**SUBJECT:** NuScale Power, LLC Response to NRC Request for Additional Information No. 58 (eRAI No. 8835) on the NuScale Design Certification Application

**REFERENCE:** U.S. Nuclear Regulatory Commission, "Request for Additional Information No. 58 (eRAI No. 8835)," dated June 08, 2017

## **Response to Request for Additional Information Docket No. 52-048**

**eRAI No.:** 8835

Figure 3.9-1: Reactor Module Showing Reactor Vessel Internals Component Assemblies

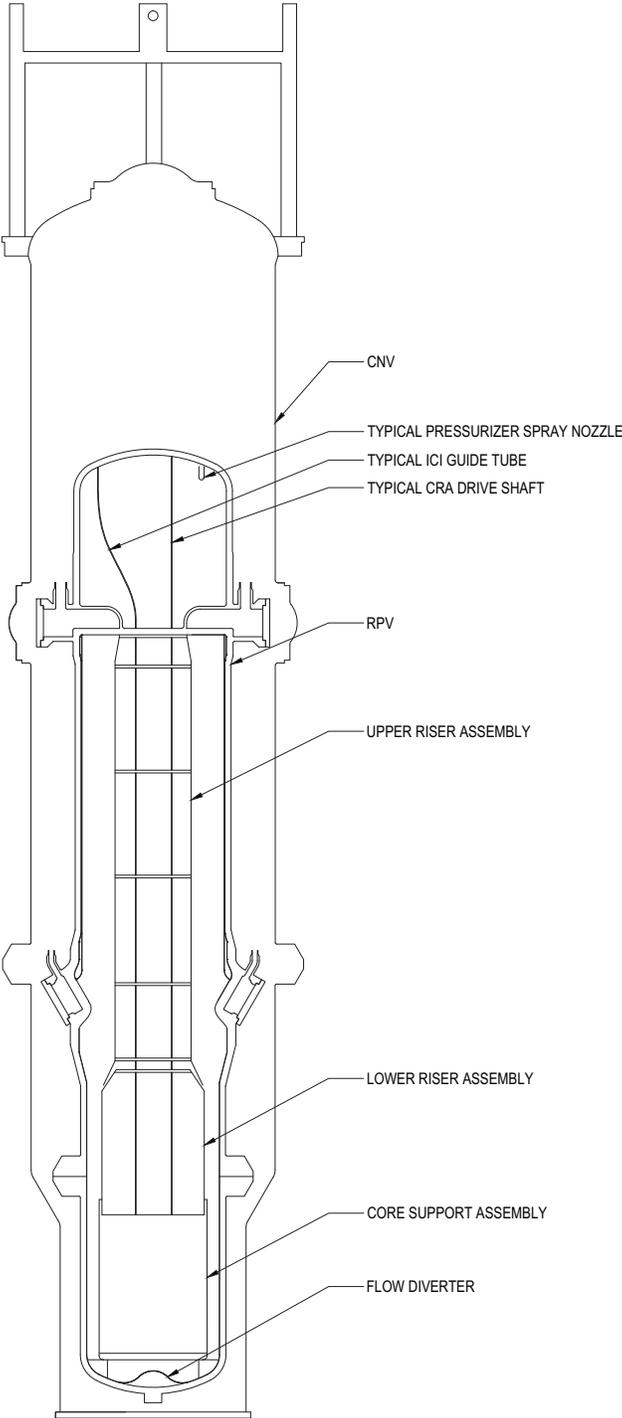
CRDM support structures are shown in Figure 4.6-1, and DCD Tier 2 Section 3.9.3.1.2 briefly mentions the CRDM seismic supports located on both the RPV and CNV head as ASME Code Class 1, Seismic Category I component supports. However, Figure 5.1-1 also illustrates the CRDM support structures, showing a different number of support structures than Figure 4.6-1. Additionally, DCD Tier 2 Section 3.9.4 does not discuss these support structures or any other means in which the CRDS is supported, despite discussion in the DCD regarding the very long length of the control rod drive shafts when compared to traditional large light water reactors. Provide an explanation of the support configuration in order for staff to make a safety finding for the review area of GDC 1 and 2.

FSAR Section 3.9.4 along with FSAR Figures 3.9-1, 3.9-2 and 5.1-1 have been revised as described in the response above and as shown in the markup provided with this response.

Figure 4.6-5: Overview of Latch Mechanism Assembly

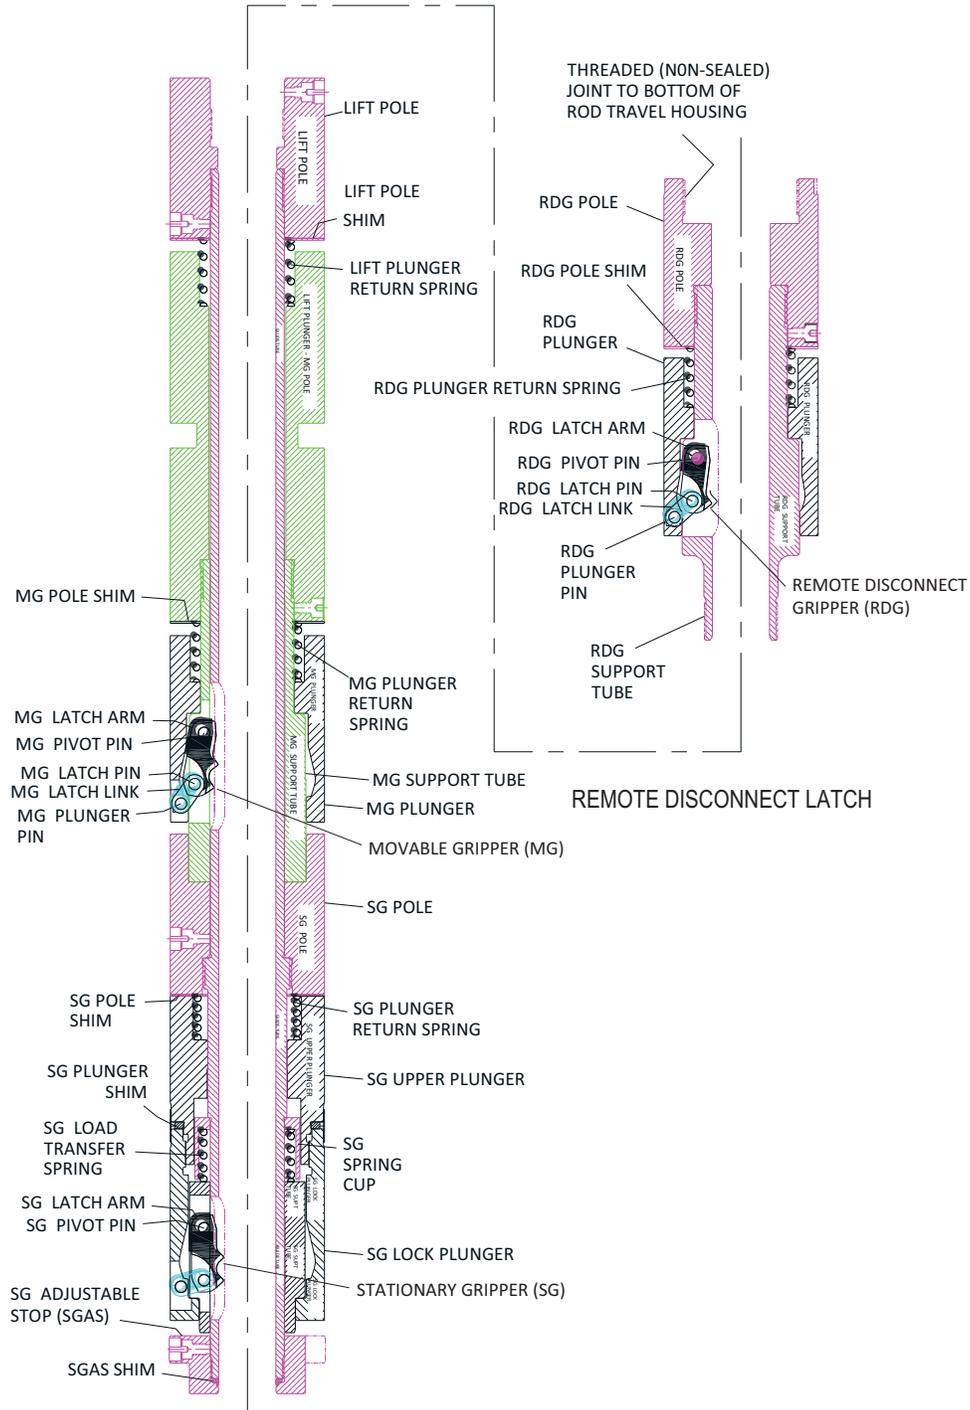
Update Figure 4.6-5 to include a detailed presentation of the configuration of the latch mechanism assembly. Also, provide definitions for acronyms contained in Figure 4.6-5. Provide legible and detailed drawings (including component identification, class breaks, and dimensions) for all drawings related to SRP Section 3.9.4 to better describe the design of this system and allow staff to make a safety finding for GDC 1, 2, and 14.

A detailed description of the latch mechanism, depicted by Figure 4.6-5, and its operation has been added to Section 3.9.4.1.1. Also, Figure 4.6-5 has been updated to define all acronyms contained in the Figure. Figure 4.6-2 has also been updated to provide a broader overview.

FSAR Sections 3.9.4 and 4.6 along with FSAR Figures 4.6-2 and 4.6-5 have been revised as described in the response above and as shown in the markup provided with this response.

The remote disconnect process is facilitated by the combined engagement of stationary grippers (SG) and remote disconnect gripper (RDG) on top of the mechanism (Figure 4.6-5) during the refueling sequence. To begin the disengagement process, the drive shaft with CRA is inserted to the post-SCRAM position and the SG coil and MG coil are energized, subsequent energizing of the RD coil lifts the top of the drive shaft by about seven inches. The first approximate four inches of this lift compresses the RD upper spring solid, the following 1½ inches lifts the drive shaft and extracts the RD coupling from the CRA hub which causes the CRA to drop. The load reduction is indicated by a current response in the RDG coil. After the next approximate 3/8 inch the drive shaft reaches its maximum elevation, and the remaining travel locates the RD coupling 1¼ inch above the elevation at which it last made contact with the CRA hub, at which point the RDG is released and the spring-loaded lower end of the drive shaft expands (Figure 4.6-6). This completes the disengagement process, the system rests now in the post-RD configuration.
